# LOWER SNAKE RIVER
# LITTLE GOOSE AND LOWER GRANITE LOCKS AND DAMS

## Adult Fishway Systems
## Emergency Auxiliary Water Supply
## Phase II – Technical Report

### Final Report

| Appendix A | Quality Control Plan and Independent Technical Reviews (ITR) |

PLATE 1.2.3

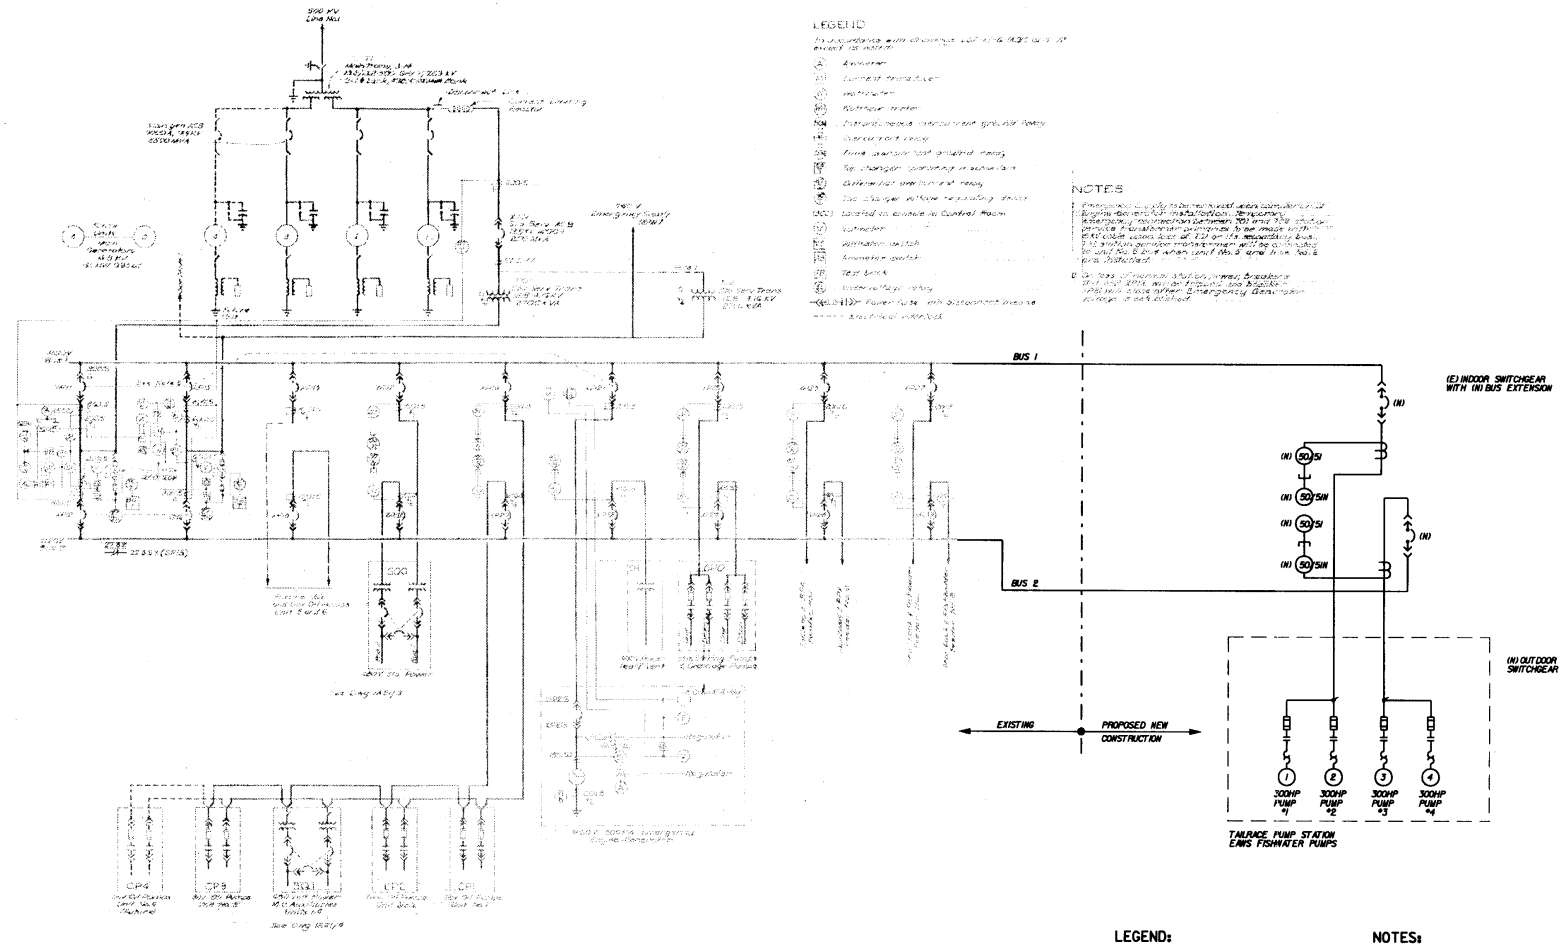
| Item No. | Dwg, Sht./Page/ Spec. Paragraph | **COMMENTS** | Action taken on Comments by: David Absher and Gerald Walker | | |
|---|---|---|---|---|---|
| 2 | Plate 1.2.3 | (N) 51 device should be (N) 50/51 (2 places)<br>(N) 51N device should be (N)50/51N (2 places) | A – Plate will be revised | **C** | DMT |

PLATE 1.3.1

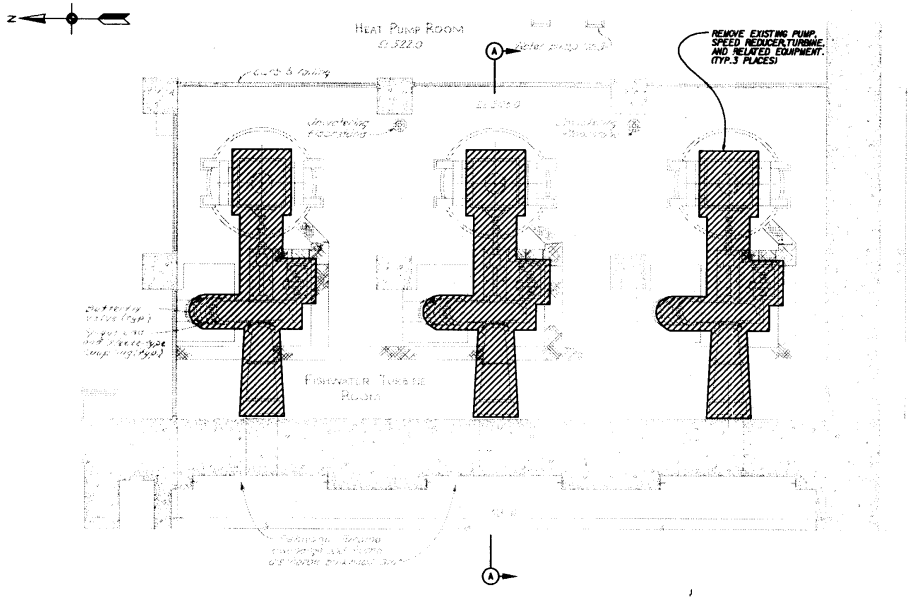
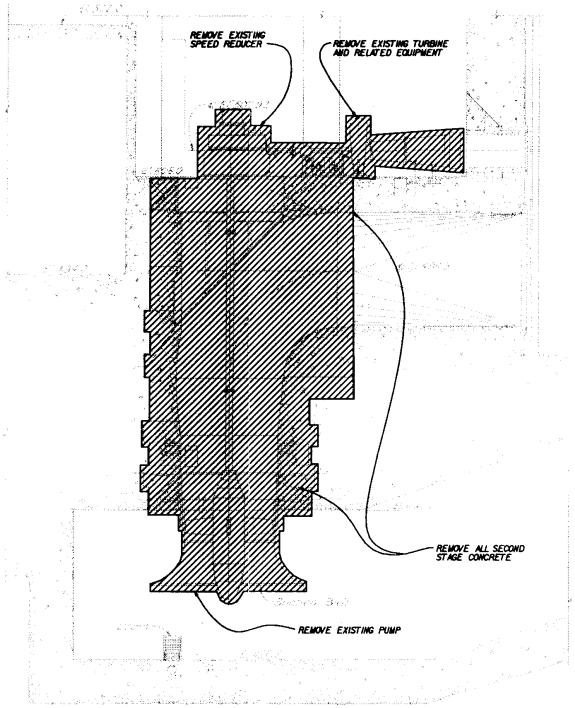
| Item No. | Drawing Sht. Spec. Para. | COMMENTS | Action taken on Comments by: Rolf Wielick, Perry Johnson, Gerald Walker, and Dave Absher | | |
|---|---|---|---|---|---|
| 53 | Plate 1.3.1 | The hatching for removal of items should probably cover the entire pump assembly in section A and the complete pump outline in the demolition plan. | **A** – Yes. The drawing will be revised. | | |

PLATE 1.3.2

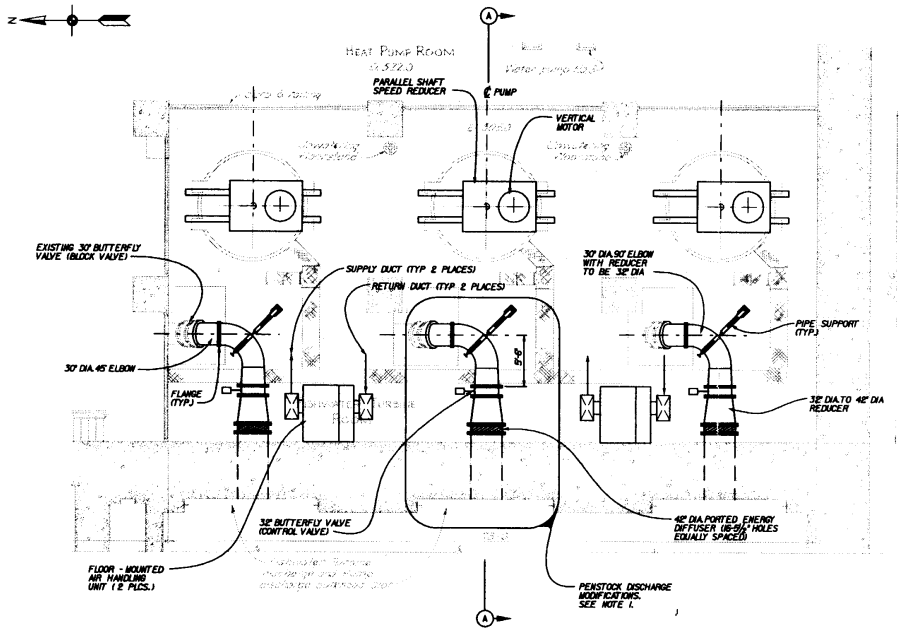
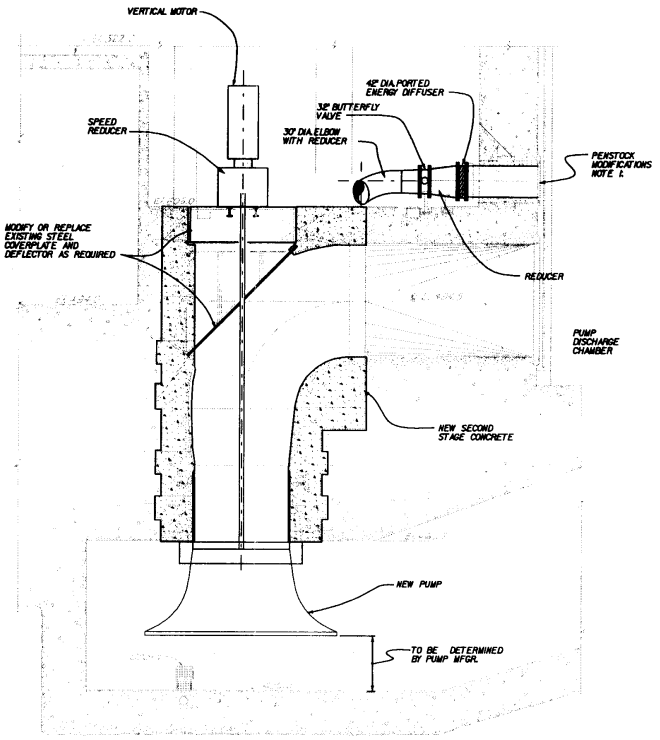
| Item No. | Drawing Sht. Spec. Para. | COMMENTS | Action taken on Comments by: Rolf Wielick, Perry Johnson, Gerald Walker, and Dave Absher | | |
|---|---|---|---|---|---|
| 48 | 4-47<br>Plate 1.3.2 | HVAC. For the HVAC system to be effective, motor enclosures will almost certainly be required. The fan coil units mounted on the floor will circulate cooler air, as the warm air will rise to the ceiling. There needs to be some method of removing the heat at its source. May want to take a closer look at what is done at Lower Granite. | **A** – The design and cost estimates envision a system of supply and return ducts for proper distribution of the cooling air ducts to distribute and return air. The text and drawings will be expanded to show this. | | |

| Item No. | Drawing Sht. Spec. Para. | COMMENTS | Action taken on Comments by: Rolf Wielick, Perry Johnson, Gerald Walker, and Dave Absher | | |
|---|---|---|---|---|---|
| 54 | Plate 1.3.2 | Fishwater Pump Room Plan. Should show the outline of entire new pumps and concrete with bold line work instead of just the new motor and gearbox. | **A** – Yes. The drawing will be revised. | | |

PLATE 1.3.3

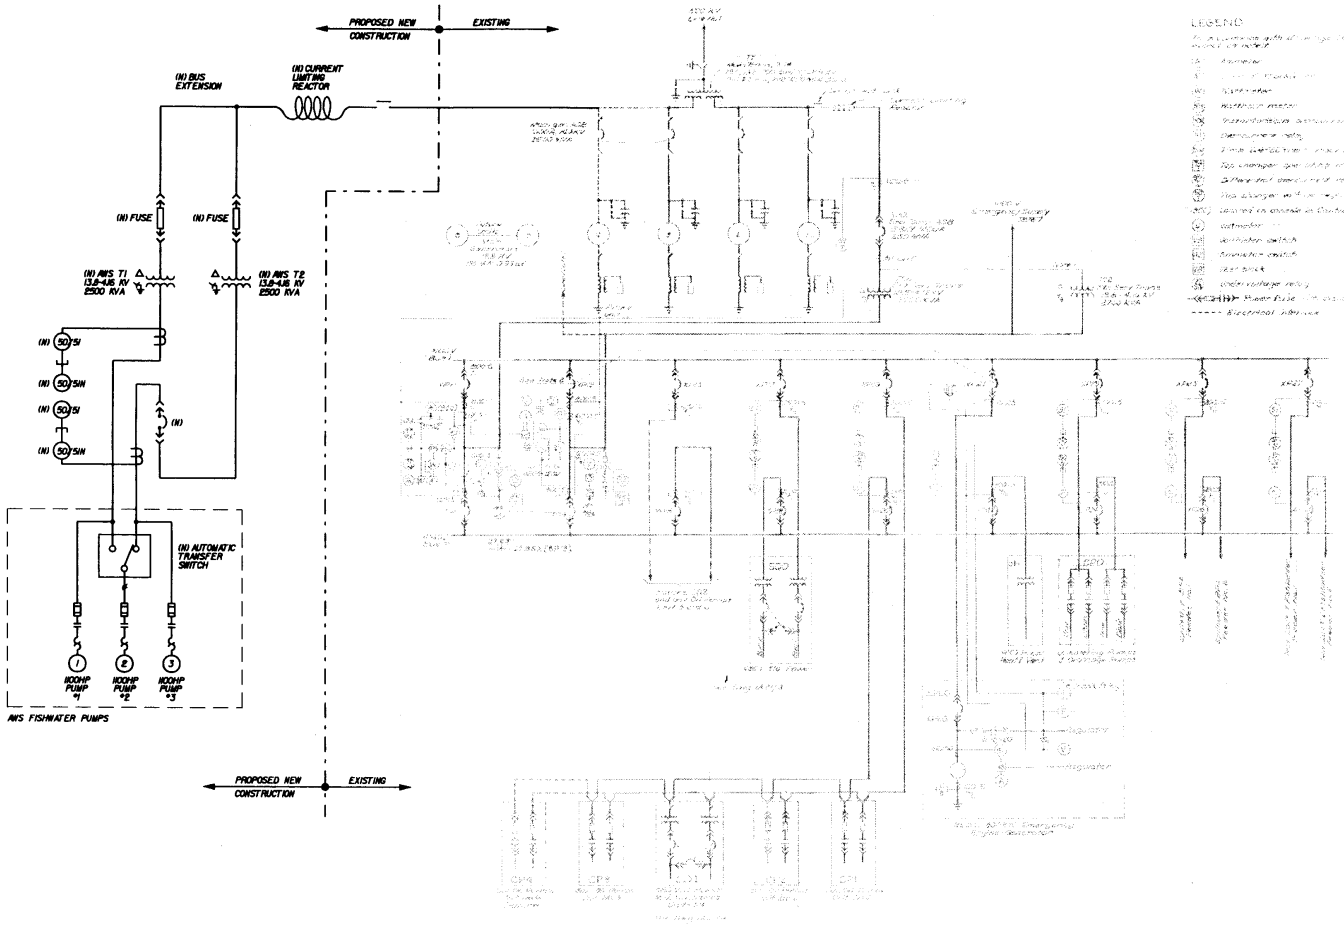
| Item No. | Dwg, Sht./Page/ Spec. Paragraph | **COMMENTS** | Action taken on Comments by: David Absher and Gerald Walker | | |
|---|---|---|---|---|---|
| 3 | Plate 1.3.3 | Same as Comment 2 | **A** – Plate will be revised | **C** | DMT |
